MEMORANDUM

REVIEW TYPE: Preliminary Plan of Subdivision

PROJECT NAME: Smoot's Addition to Chevy Chase
CASE #: 120070060
REVIEW BASIS: Chapter 50, Montgomery County Subdivision Regulations

7401 BROOKVILLE ROAD
PROPOSED LOT 2, BLOCK B
SMOOT'S ADDITION TO CHEVY CHASE SECTION 5
PRELIMINARY PLAN

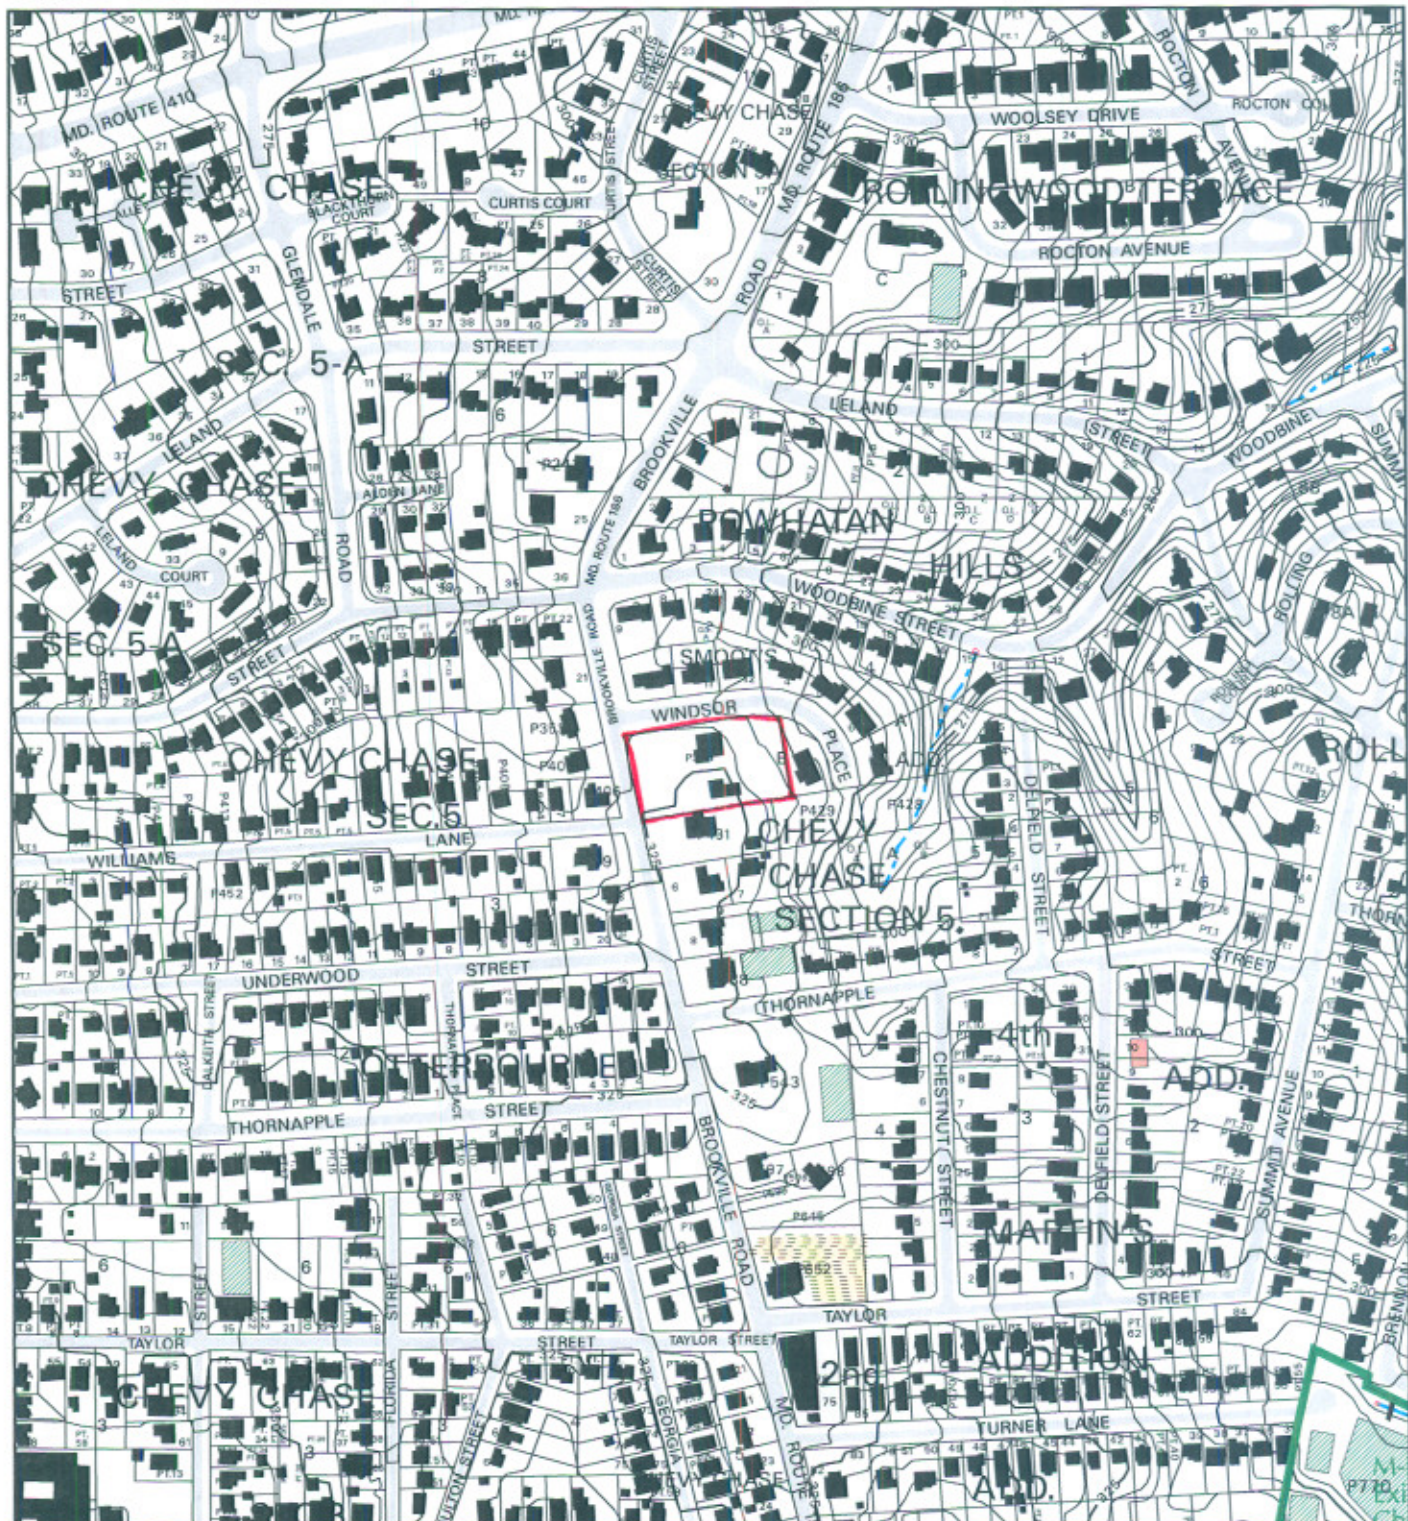
1. Show/label all existing planimetric and topographic details specifically storm drainage, driveways adjacent and opposite the site, sidewalks and/or bikeways as well as existing rights of way on both sides and easements on the preliminary plan.

2. We did not receive complete analyses of the capacity of the downstream public storm system(s) and the impact of the post-development runoff on the system(s). As a result, we are unable to offer comments on the need for possible improvements to the system(s) by this applicant. Prior to approval of the record plat by the Department of Permitting Services (DPS), the applicant's consultant will need to submit this study, with computations, for review and approval by DPS. Analyze the capacity of the existing downstream public storm drain system and the impact of the post-development ten (10) year storm runoff on same. If the proposed subdivision drains to an existing closed section street, include spread and inlet efficiency computations in the impact analysis.
